**MUNICIPAL PLANNING COMMISSION AGENDA
SUMMER VILLAGE OF NORGLNWOLD
SUMMER VILLAGES ADMINISTRATION OFFICE
JULY 9, 2021 @ 9:00 A.M.**

Summer Village of Norglenwold – Municipal Planning Commission**July 9, 2021****Agenda Item****205 Grand Avenue (Lot 13, Block 2, Plan 2203KS)****Development Permit Application****Background:**

The registered homeowner submitted an application for escarpment work, boathouse repairs and tree removal to take place at 205 Grand Avenue (Lot 13, Block 2, Plan 2203KS) in the Summer Village of Norglenwold. This property is in the R-S District (Shoreline Residential).

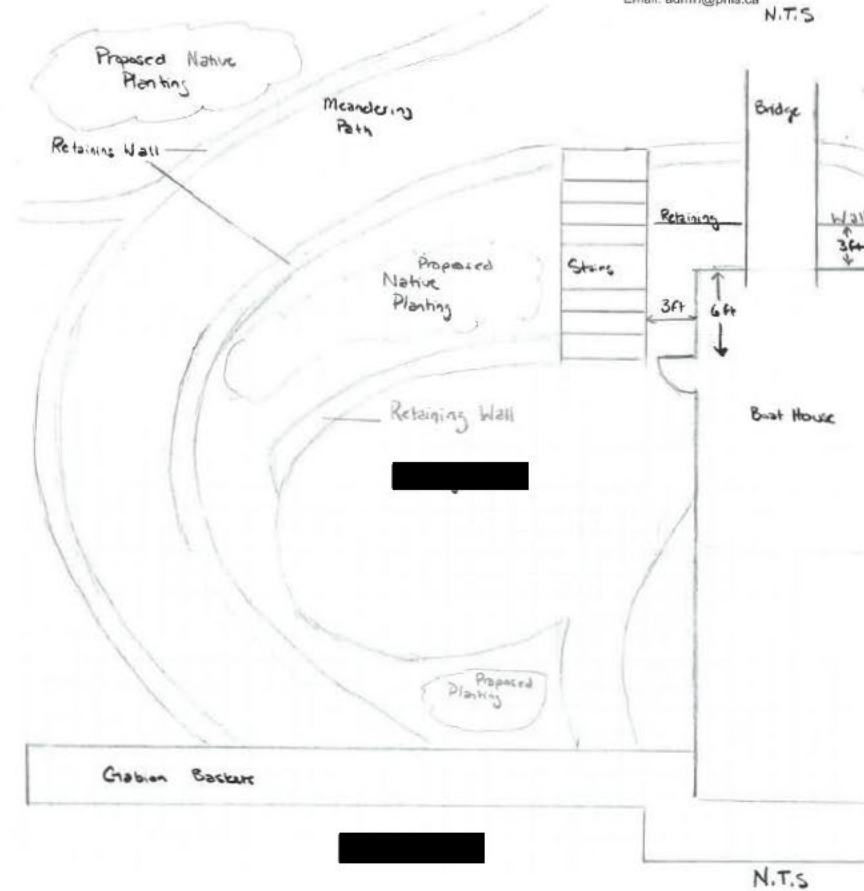
- Looking at the plan for the escarpment area and along with our statutory documents generally we wouldn't want to see both a meandering path and stairs. The idea of having a meandering path is to keep the area as natural as possible with a natural like meandering path, the additional stairs wouldn't be seen as necessary when there is both. The stairwell will be for access to the boat house and a safe access with a handrail for elderly users. The meandering path follows the recommendation of the geo-tech report that we keep the slope at 1:4 while maintaining bank stabilization vegetation. As there isn't a clear and safe access point to the lake from the top of the escarpment at this time, we designed a meandering path down as the primary access to the lake. The stairs that are already there would be refurbished and provide access to the boat house and for the physically compromised users to the water

- I see there is sand in the plans, we like to see at least a 1m no mow zone adjacent to the lake as man-made beaches/sand can easily erode.
This will now be a natural area, no sand. The area surrounding the seating area as well as the embankment will be planted with native plant material once the embankment is reshaped. The native plantings will help stabilize the bank and prevent erosion. Remember this area is behind the gabions, which are 1 metre high and 1 meter wide.

Boathouse Repair Concept

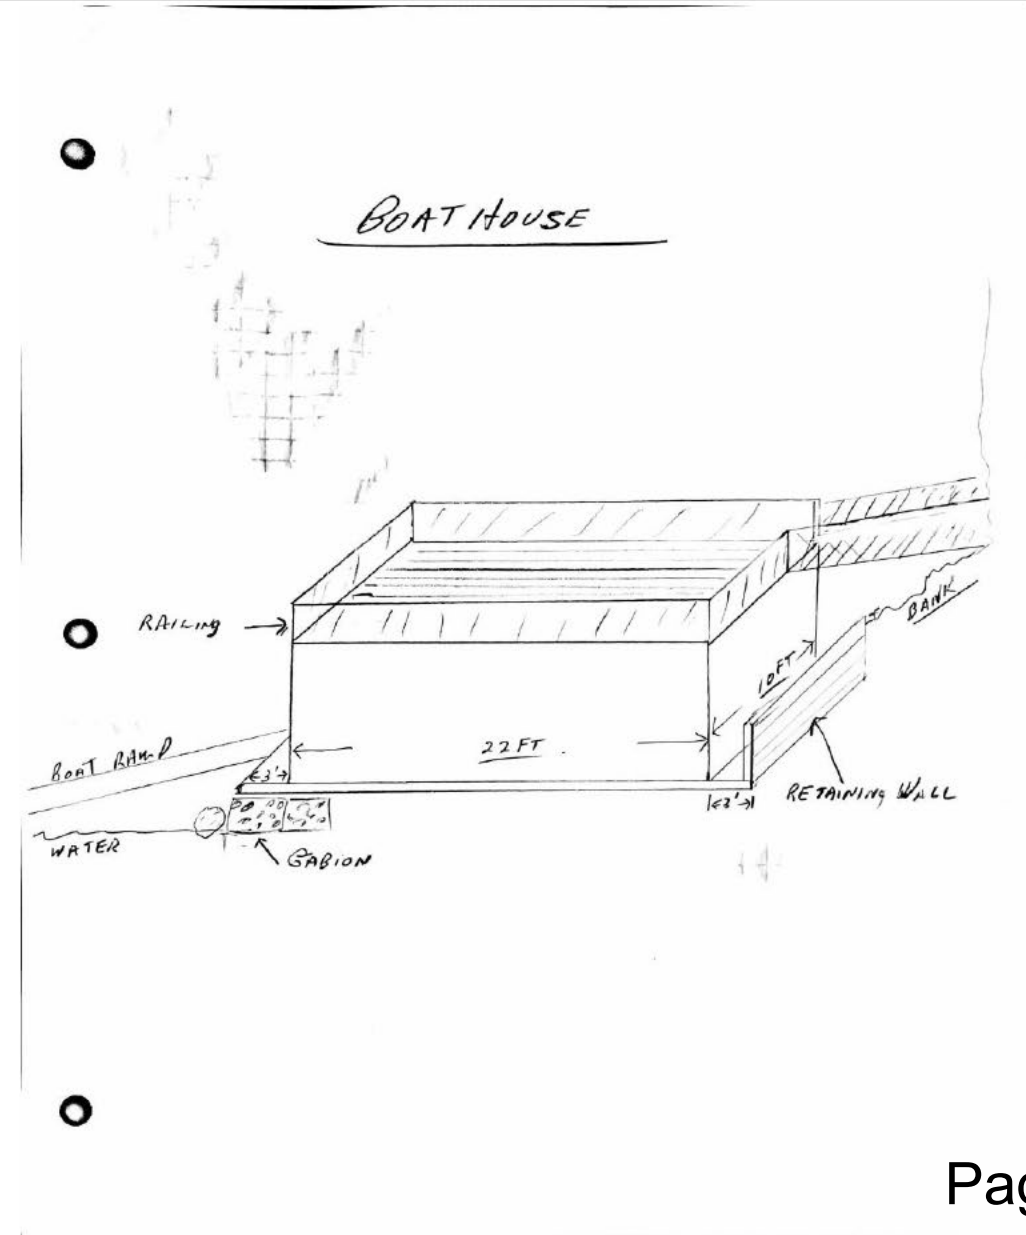
- It is clear that the intent is to fully remove this boathouse and put it back, I would not call this repairs. I understand that you want to do work to the bank and want to keep the boathouse but I would not classify it as routine maintenance which is something that could be allowed depending on the type of maintenance and how much. If a non-conforming building (boathouse) is damaged or destroyed to the extent of more than 75% of the value of the building above its foundation, the building may not be repaired or rebuilt except in accordance with the land use bylaw, again, these repairs would be considered very significant especially since the boathouse would have to be removed. As boathouses aren't allowed to be newly constructed generally if it has to be completely removed, we wouldn't recommend for MPC to approve it to go back.

Tree Removal

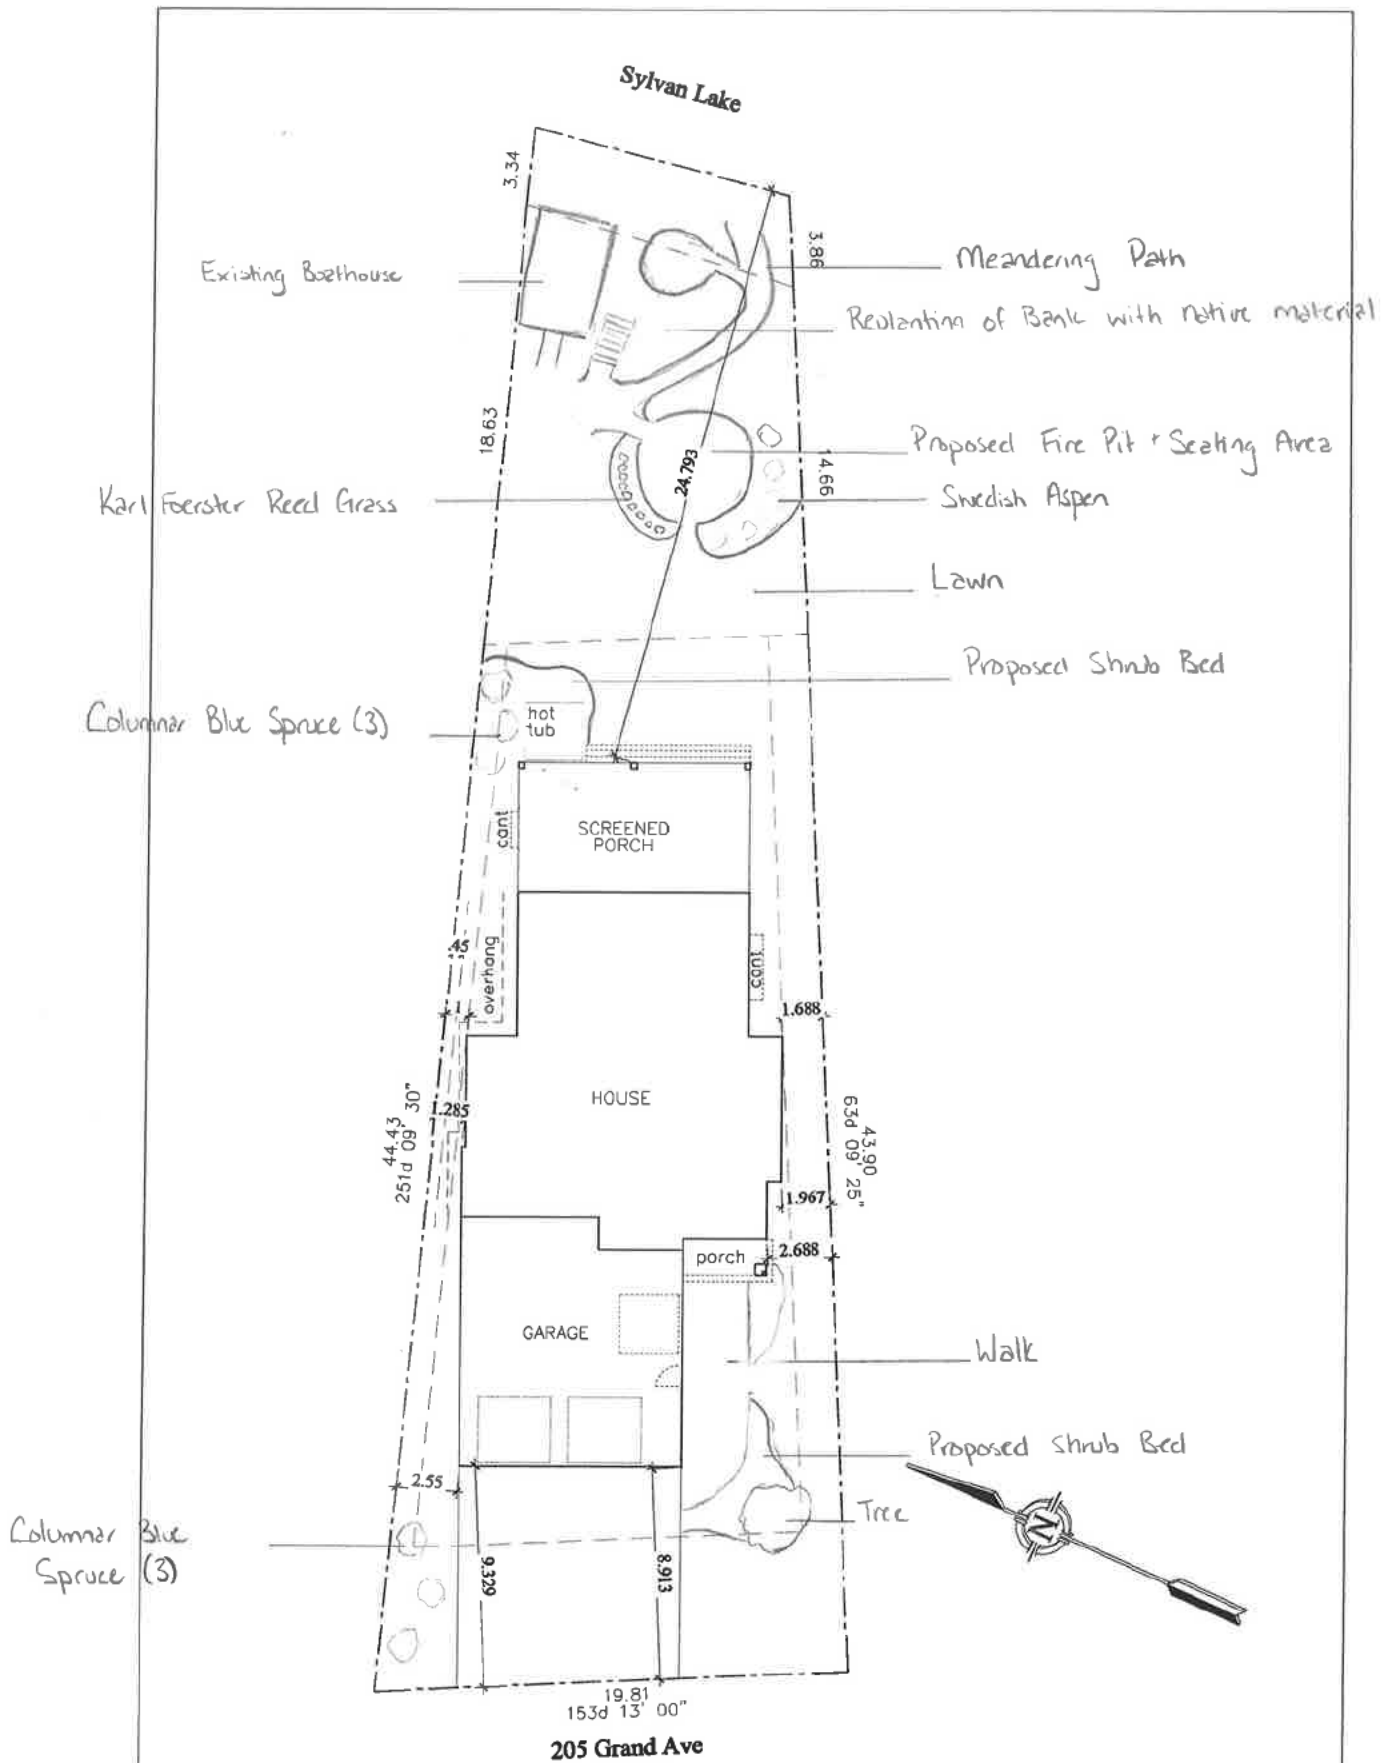
For the tree removal plan part of things, my understanding is that you will be applying for a dwelling as well. I also understand it would make sense to have those trees removed at the same time while other work is getting done and don't have the re-planting plans yet but I do think the Municipal Planning Commission would want to see some sort of re-planting plan, if you are able to provide something showing even where you plan to have the house and where you plan to replace trees/shrubs for the new building plans that will come in. Just so they have an idea and understand your intent to replace them.

- The attached plot plan is the first draft which shows proposed landscaping with the minimum trees and shrub beds. It is our desire to keep as much of the natural trees we can and not remove but sometimes once you get into a deeper inspection, age, disease and individual tree damages can change these plans.
